DENON *Service Information*

DENON, LTD.
INTERNATIONAL SALES DIVISION
REF. NO: OST-760
DATE: September 2003

1. **MODEL:** AVR-1403, AVR-1603 and AVR-1803, All E Models.
(Refer to the page 3/3 for details.)
2. **SUBJECT:** Serial Numbers to which the countermeasure for the cracked P. W. Board has been applied upon production of the units.

Fig. 1

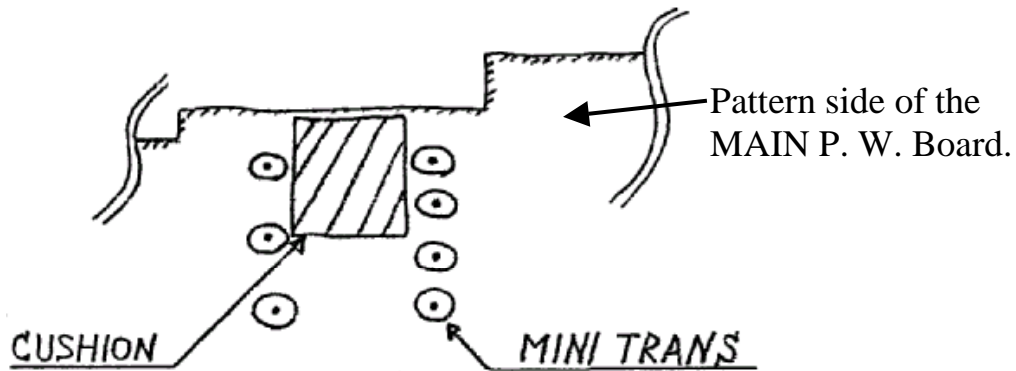
3. **SYMPTOM:** In case of the AVR-1403 G1C, the pattern was disconnected due to a crack of the P. W. Board of the MINI TRANS section, and a failure occurred that the Power is not turned on.

4. **CAUSE:** The yield strength of the unit against the vibration and/or the drop was reduced due to an increase of the gap between the P. W. Board and the MINI TRANS and the weight of the MINI TRANS part than the former model.

- 3) Attach the Cushion (963 0099 709) on the pattern side of the P. W. Board of the MINI TRANS. (Fig. 1)
- 4) Apply Bond (SC608Z) to the leg portions of the MINI TRANS to fix the legs on the P. W. Board. (Fig. 2)
